Iron of Abington Sld. report No 13029

S. S. No 143.

Section through Boiler Space

Section on Frame 63

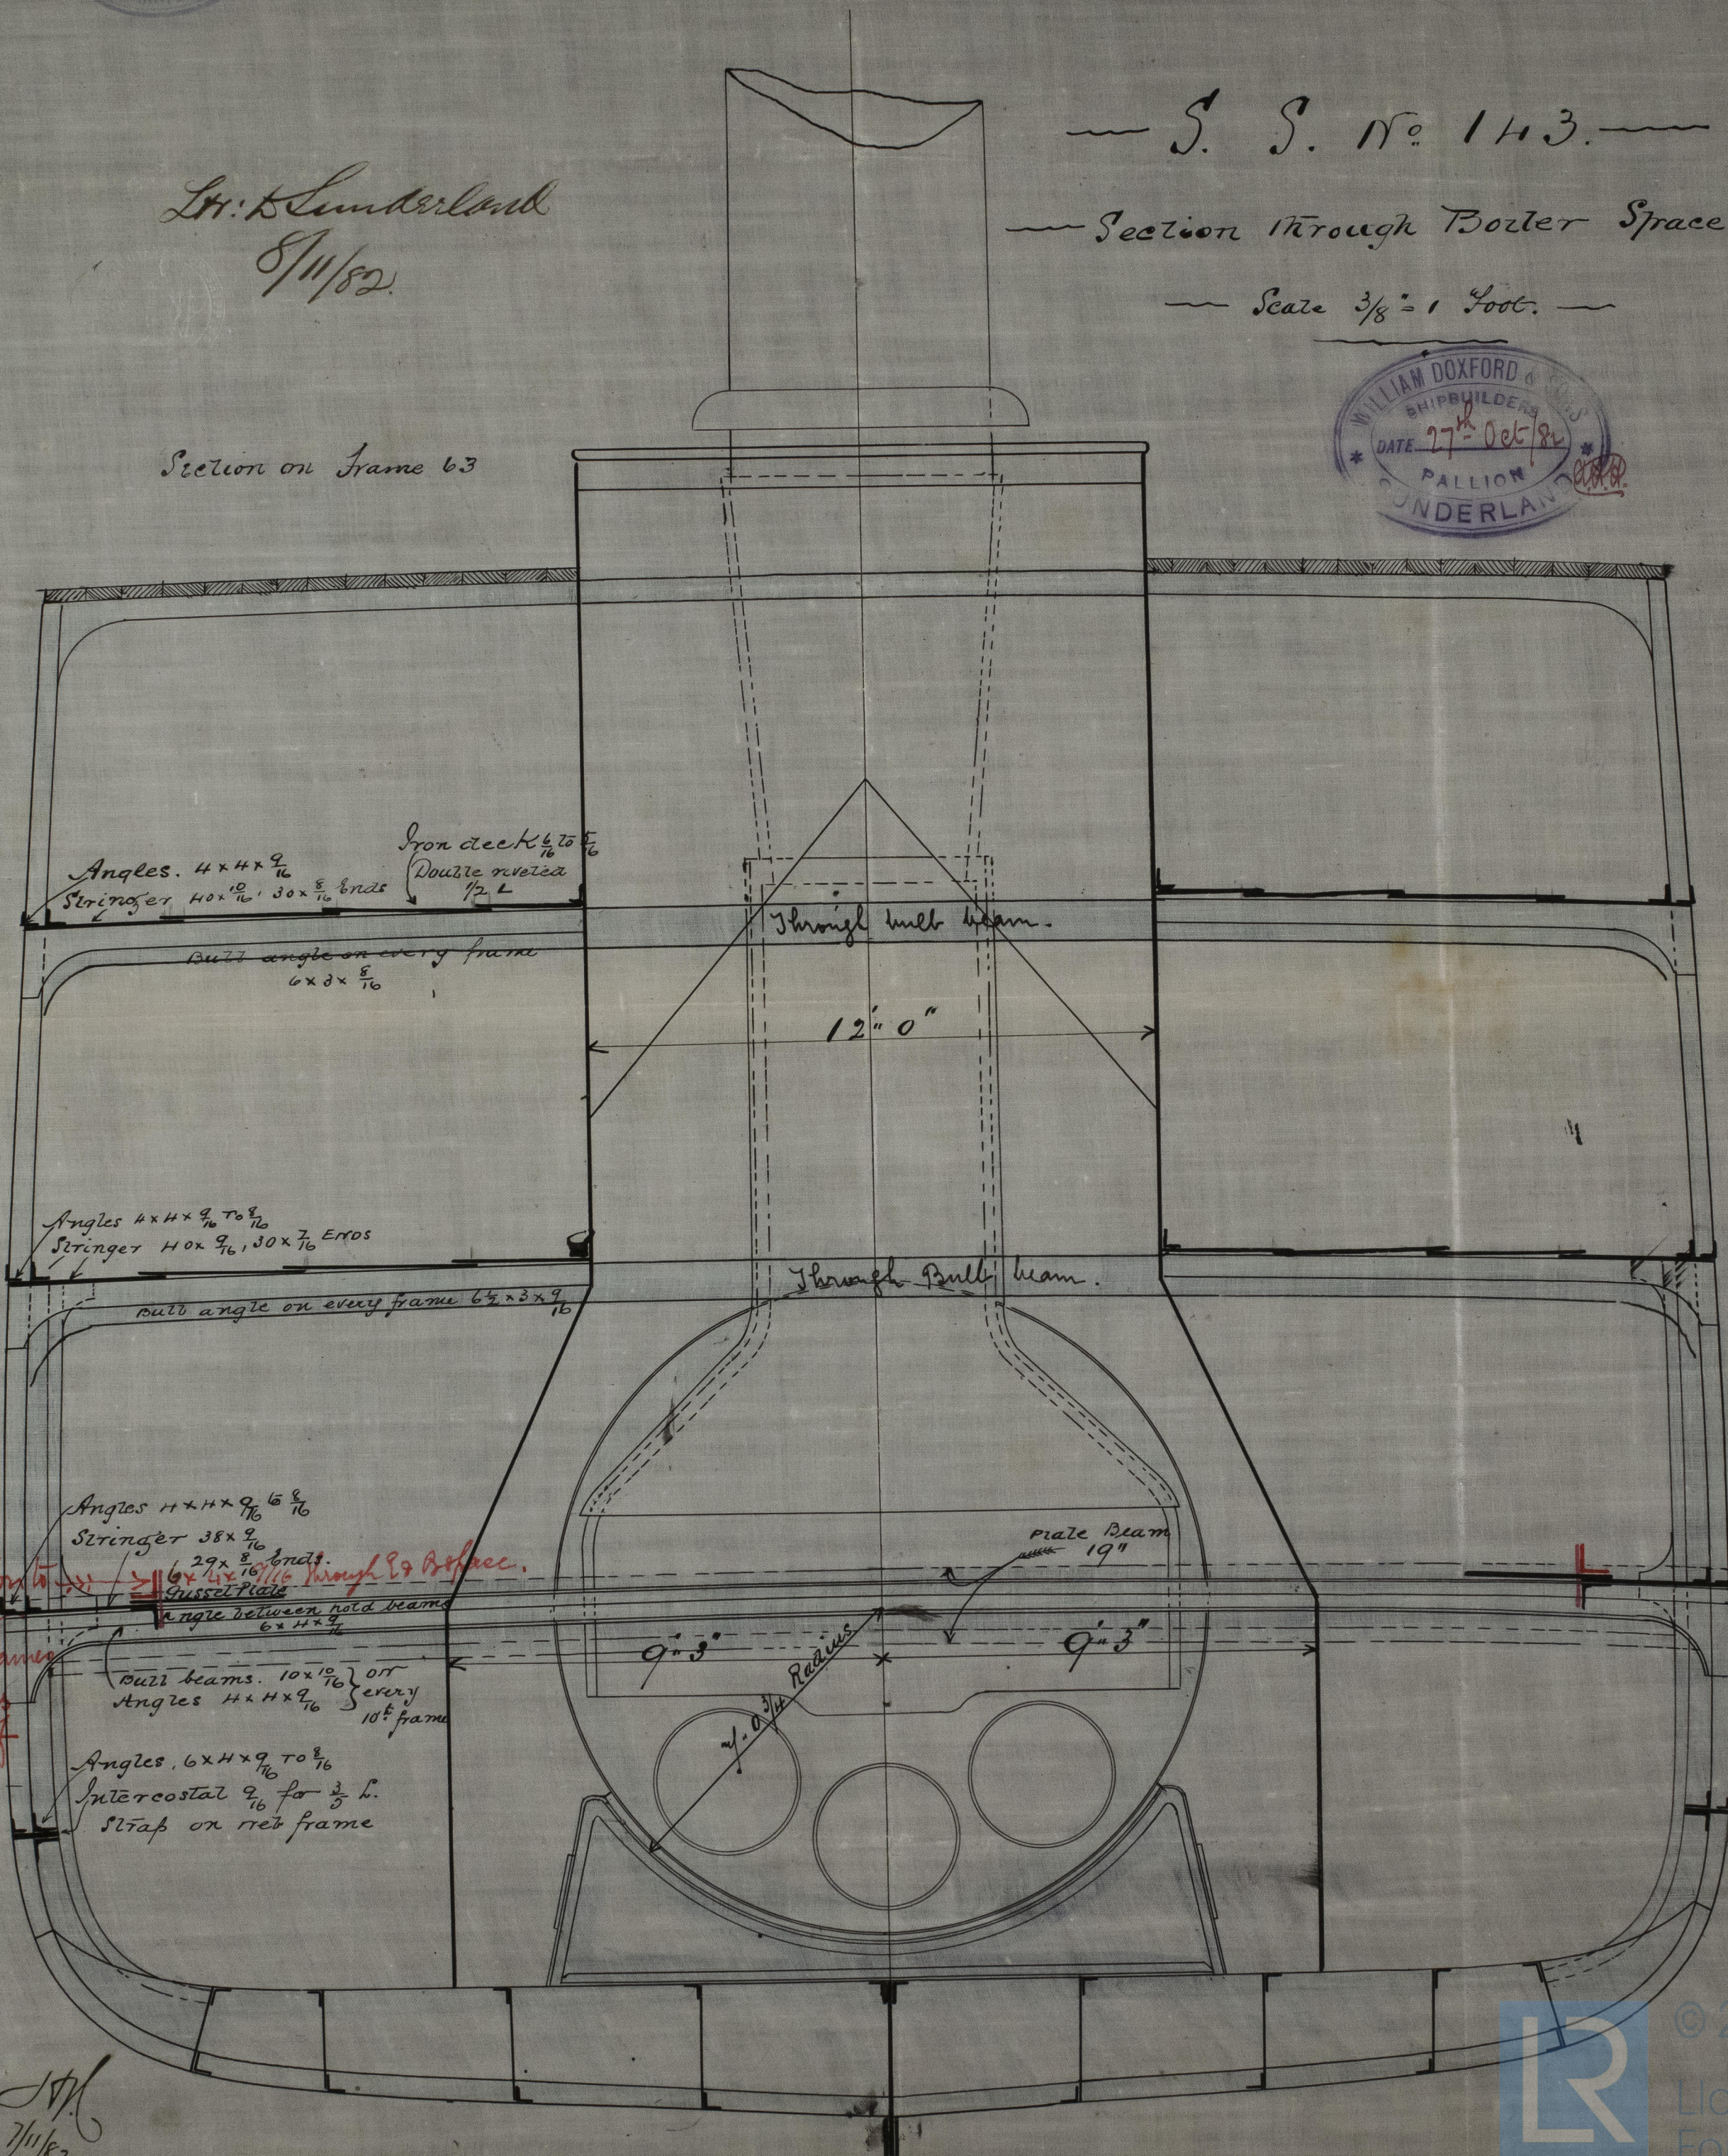
Proposed addition to compensate for spacing of web frames which are 6 spaces apart instead of five.
